ADDENDUM 1

PROJECT NAME: Fuel Sump Replacement – Central PD

PROJECT NO: 35-00359

RE: Central Service Area Police Department – Addendum 1_Narrative of Revisions

DEMOLITION PLAN

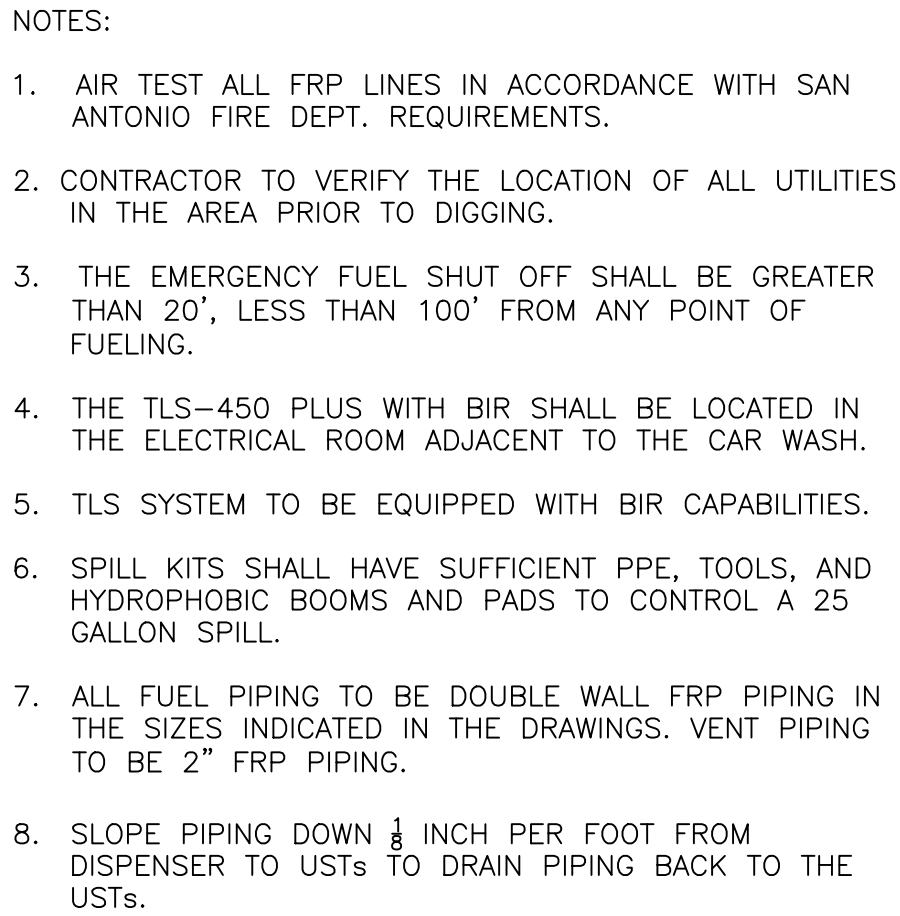
QUESTION: 6. SHEET F-4 NOTE #4 FOR THE TANK PAD STATES, ANY FILL BUCKETS OR COMPONENTS DAMAGED DURING CONSTRUCTION SHOULD BE REPLACED, WILL A CHANGE ORDER BE SUBMITTED FOR APPROVAL? OTHERWISE, WE RECOMMEND CITY TO REQUIRE REPLACEMENT OF THESE COMPONENTS IN THE SCOPE.

- F-1: No Changes
- F-2: No Changes
- F-3: No Changes.
- F-4: UST removal notes revised to direct contractor to replace pump sumps, vapor recovery and spill buckets.
Note revised to reuse diesel dispenser and configure to dispense unleaded
- F-5: Note revised to reuse diesel dispenser and configure to dispense unleaded
- F-5A: Note revised to reuse diesel dispenser and configure to dispense unleaded
- F-6: No Changes.
- F-7: No Changes.
- F-8: No Changes..
- F-9: No Changes.
- F-10: No Changes.
- F-11: No Changes.

- PLAN FOR THIS AREA- VENT PIPING AND VENT
1. REUSE EXISTING VENT PIPING AND VENT EQUIPMENT.
 2. REPLACE ANY DAMAGED COMPONENTS OF THE VENT SYSTEM.
 3. EXTEND VENT PIPING TO 5' ABOVE WASH BAY SOFFITT.

ANSWER: NO, SEE ANSWER TO PREVIOUS QUESTION 8.

1	2025/7/24	NOTES REVISED	
NO	DATE	REVISION	BY

F-5A

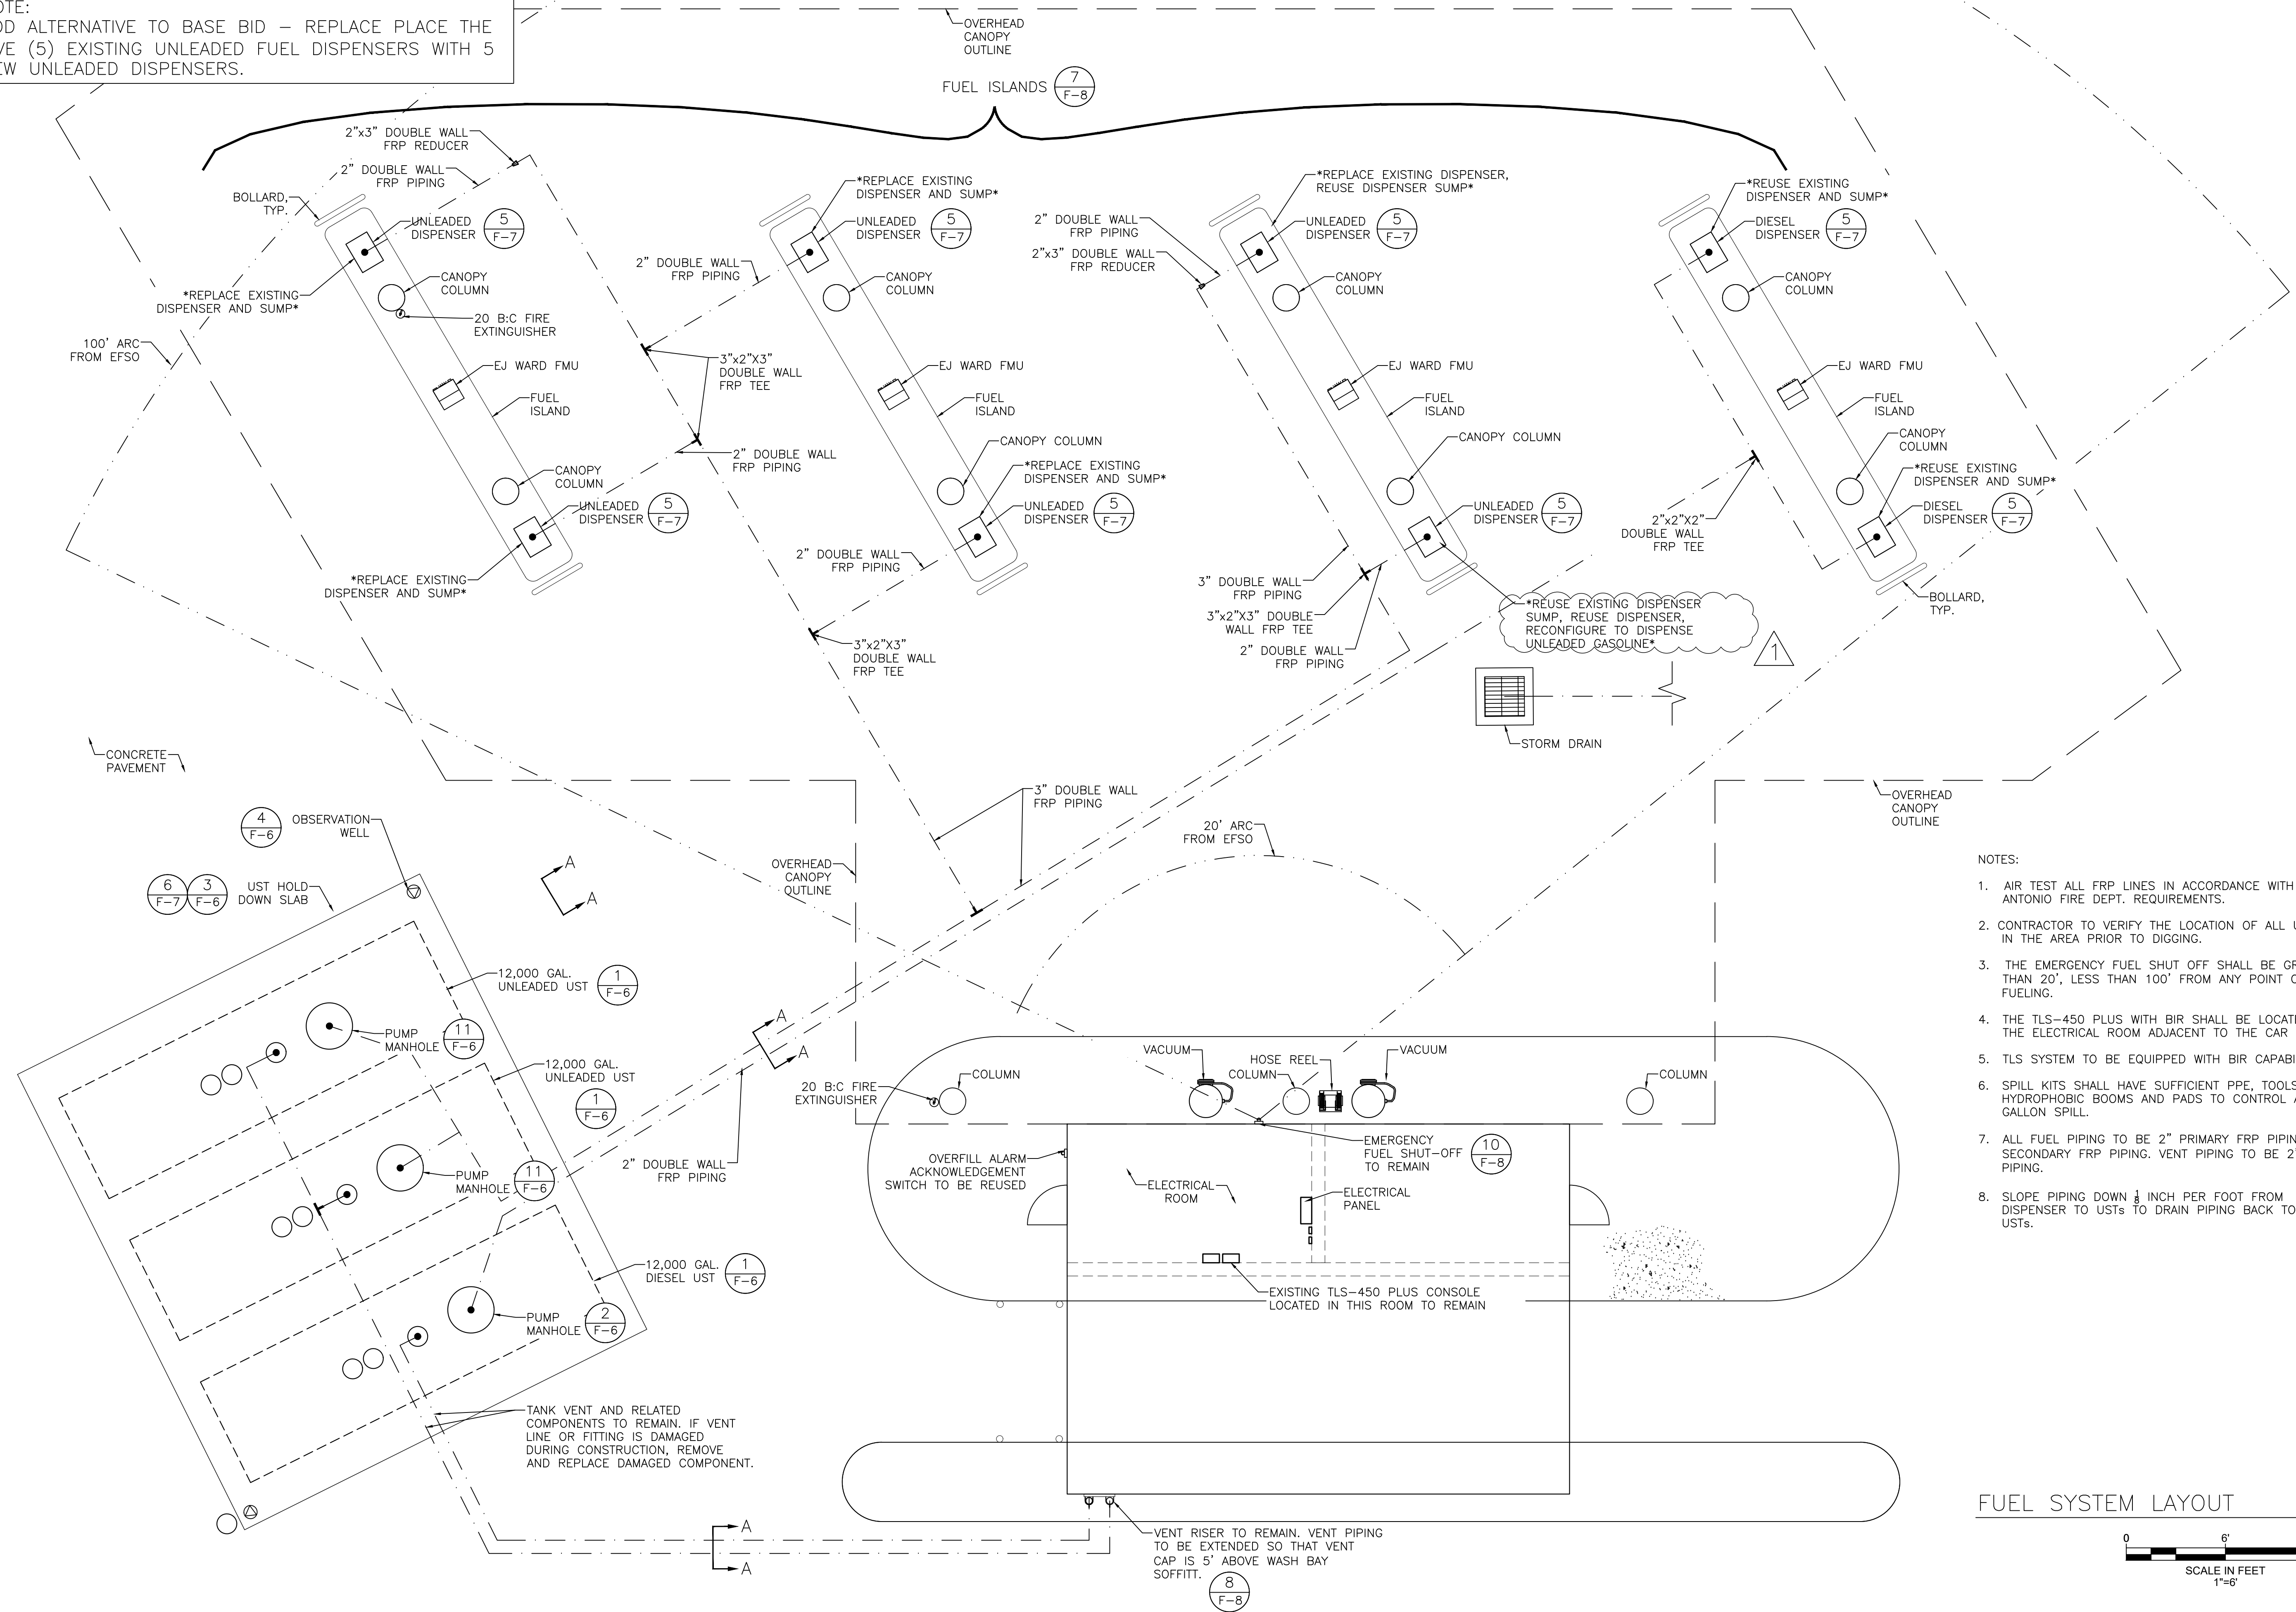
QUESTION: 5. SHEET F-5 SHOWS THE UNLEADED FUEL LINE TO TEE OFF BETWEEN THE 1ST AND 2ND FUEL ISLANDS, BUT SHEET F-4 SHOWS THE DEMO FOR THE FIRST FUEL ISLAND IN FRONT WHERE THE PIPING IS TO BE REMOVED. WILL THE CITY UPDATE THE DEMO PLAN FOR THE ADDITIONAL CONCRETE DEMO AND REPLACEMENT IF WE ARE TO FOLLOW THE NEW PRODUCT LINE PLAN ON SHEET F-5?

QUESTION: 7. WILL THE CITY CONFIRM PER PAGE F-5 THAT WE WILL RE-USE THE EXISTING DIESEL DISPENSER AS AN UNLEADED DISPENSER OR WILL WE BE REQUIRED TO UPGRADE THE DOORS, LABELS AND HANGING HARDWARE TO UNLEADED FROM DIESEL FUELS?

NOTE:
ADD ALTERNATIVE TO BASE BID - REPLACE PLACE THE
FIVE (5) EXISTING UNLEADED FUEL DISPENSERS WITH 5
NEW UNLEADED DISPENSERS.

ANSWER: NO, THE DEMO PLAN IS FOR THE PIPE REMOVAL ALONE.

ANSWER: YES, REUSE THE EXISTING DIESEL DISPENSER AS AN UNLEADED DISPENSER AND UPGRADE THE DOORS, LABELS AND HANGING HARDWARE TO UNLEADED FROM DIESEL FUELS

8 VENT RISER DETAIL
F-5

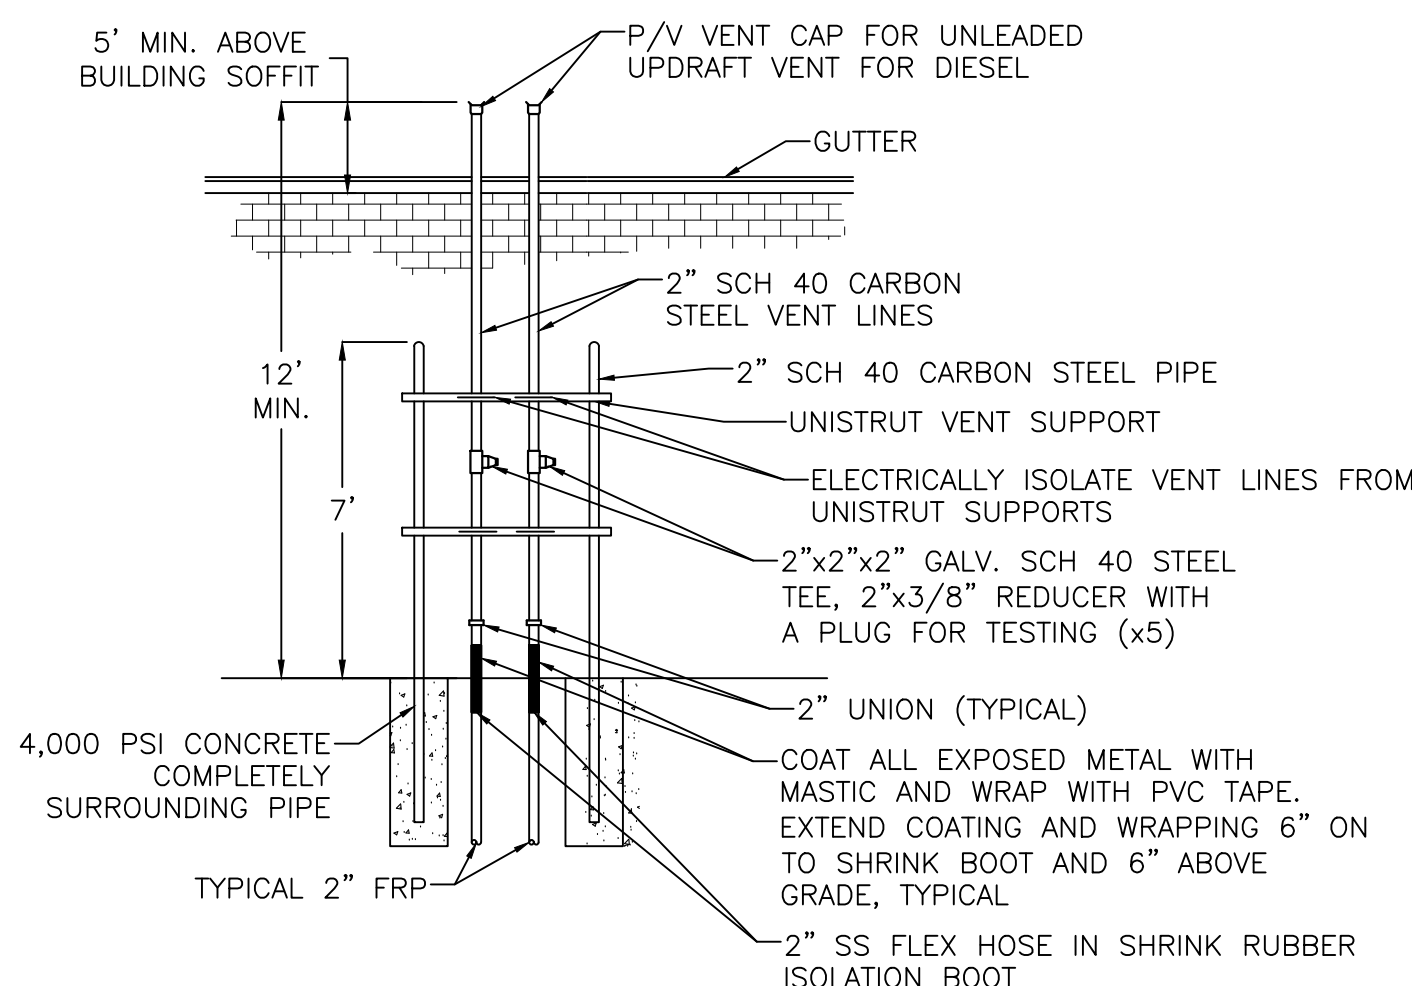
6. QUESTION: ARE WE TO REPLACE THE TANK VENT PIPING?

ANSWER: NO, BUT WE DO NEED TO EXTEND THE EXISTING VENT RISER SO THE VENT IS 5' ABOVE THE WASH BAY SOFFIT.

10 EMERGENCY SHUT-OFF DETAIL
F-5

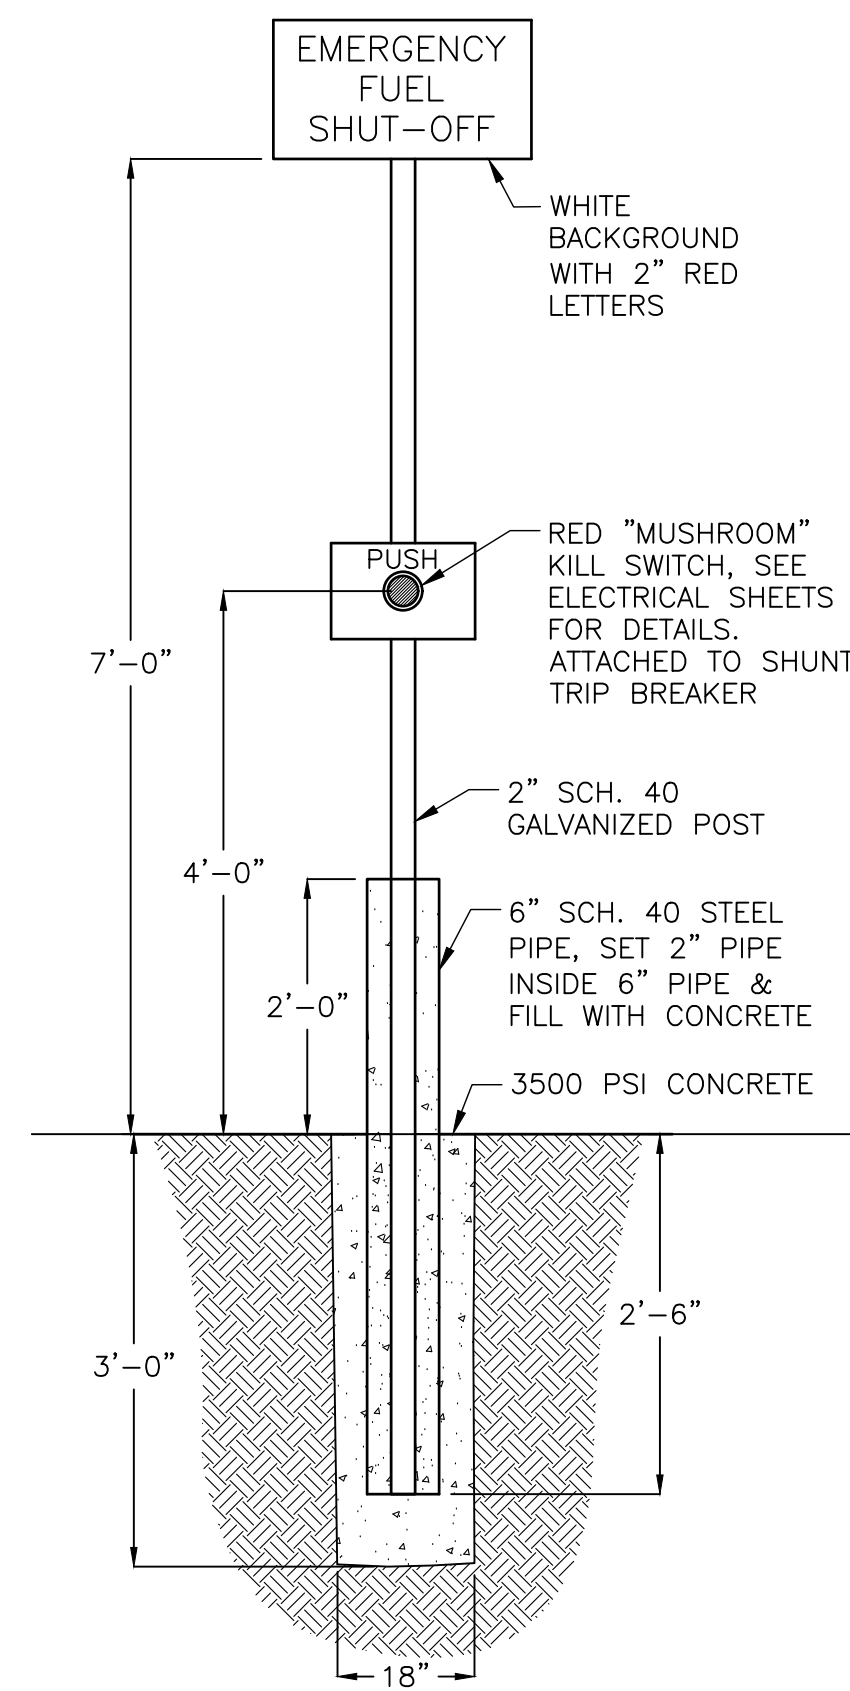
QUESTION: 10. WILL THE EMERGENCY SHUT OFF SWITCH BE REPLACED PER DETAIL ON SHEET F-8 DETAIL 10?

ANSWER: NO, REUSE THE EFSO
